## E5810A-03A

# S E R V I C E N O T E

## E5810A – LAN/GPIB Gateway

### E5810A Hang Upon Turned On

(Picture 2: Unscrew the screw using Trox T8 Screwdriver)

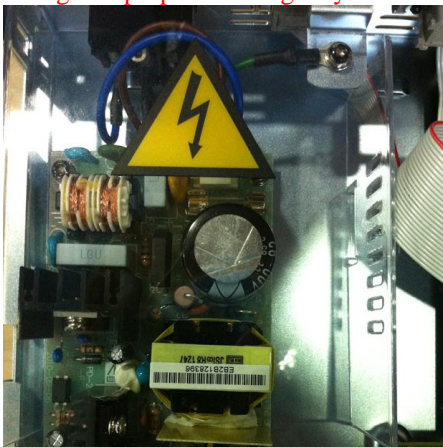
2. Loosen the screw using Torx T8 screwdriver anti-clockwise

(Picture 3: Measure output Voltage with Digital Multi-meter)

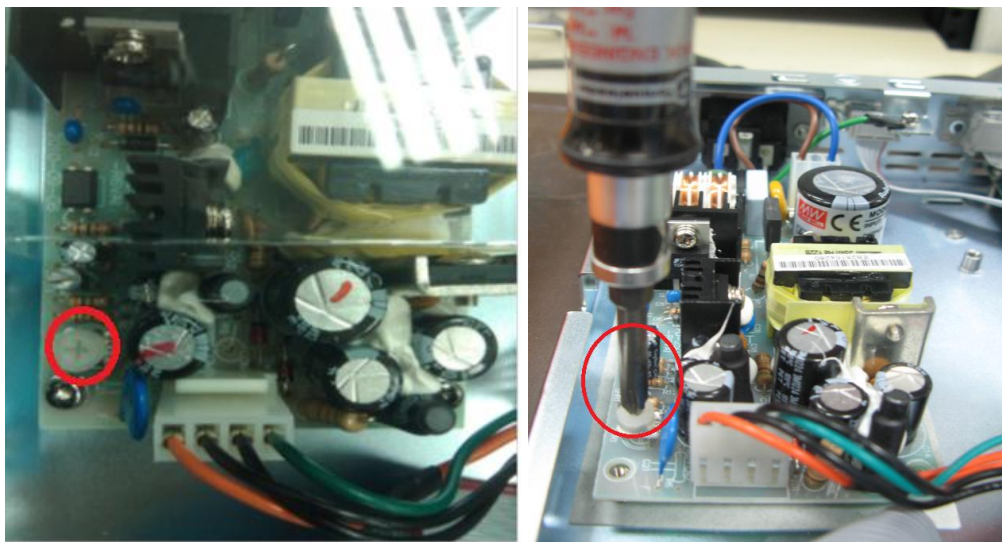
3. Measure the variable power supply using a digital multi-meter. **Note: Please be caution when measure the voltage. Improper handling may cause electric shock**

4. To adjust the variable power supply output voltage, turn the variable knob clockwise/anti-clockwise with a screw driver. (refer Picture 2) **Note : Keysight recommends to tune the power supply voltage to 3.3V**
